Access Compliance Report Public Rights-of-Way (Curb Ramps)

Main Street: LONGFIELD_LN Cross Street: HANCEFORD_RD Location: NE

ADA ID: RPRK211026135238 Ramp Type: Type 4 - Parallel Initial Pass/Fail: Pass Overall Compliance: No Severity Score: 20

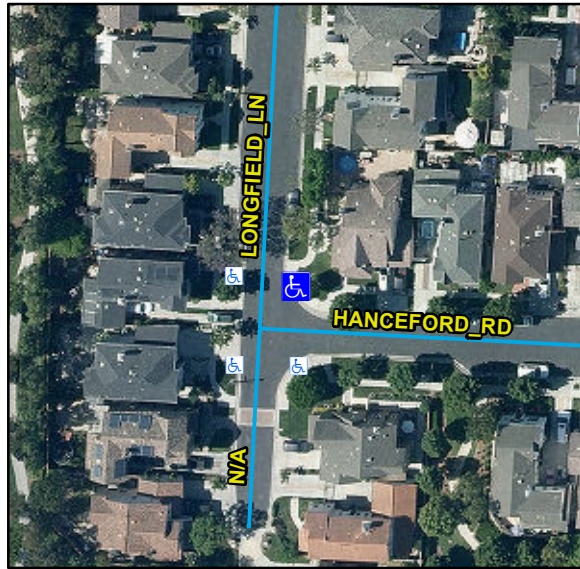
Compliance	Description	Data	Compliance	Description	Data
N/A	Ramp Length LT (in)	130	N/A	Ramp Length RT (in)	139
Yes	Ramp Width LT (in)	53	Yes	Ramp Width RT (in)	54
Yes	Ramp Run Slope LT (%)	8.2	Yes	Ramp Run Slope RT (%)	3.2
Yes	Ramp Cross Slope LT (%)	1.3	Yes	Ramp Cross Slope RT (%)	1.1
N/A	Landing Present	No	No	DWS Provided	No
N/A	Landing Length (in)	N/A	N/A	DWS Contrast	N/A
No	Landing Width (in)	N/A	N/A	DWS Length (in)	N/A
No	Landing Run Slope (%)	N/A	N/A	DWS Full Width	N/A
No	Landing Cross Slope (%)	N/A		DWS Offset Type	N/A
N/A	Landing Movement Obstructed?	No	N/A	DWS Offset Left (in)	N/A
	Landing Movement Type	Curb	N/A	DWS Offset Right (in)	N/A
N/A	Landing Shared	N/A			
N/A	Clear Space	Yes			
N/A	Clear Space To Crosswalk (in)	48			
N/A	Marked Crosswalk 1	No	N/A	Marked Crosswalk 2	No
	Crossing 1 Direction	W		Crossing 2 Direction	S
N/A	Marked Crosswalk 1 Width (in)	N/A		Marked Crosswalk 2 Width (in)	N/A
N/A	Ramp Inside Crosswalk 1	N/A	N/A	Ramp Inside Crosswalk 2	N/A

Crossing 1 Slope (%)	3		Crossing 2 Slope (%)	2.4
	Crossing 1 Cross Slope (%)	2.9		Crossing 2 Cross Slope (%)	1.4
Yes	Gutter Ponding	No	Yes	Curb Slope	1.6
Yes	Gutter Lip Height (in)	0		Road Run Slope (%)	2.5
Yes	Gutter Run Slope (%)	2.3		Road Cross Slope (%)	5
No	Gutter Cross Slope (%)	4.1	No	Perpendicular Joint Present	No
Yes	Overall Surface Condition	Acceptable			
	Cross Gutter Present?	No		Spandrel Present?	No
	Replace Cross Gutter?	N/A		Replace Spandrel?	N/A

Remove & Replace Curb Ramp With Two New Directional Ramps or Equivalent. Remove & Replace Gutter.
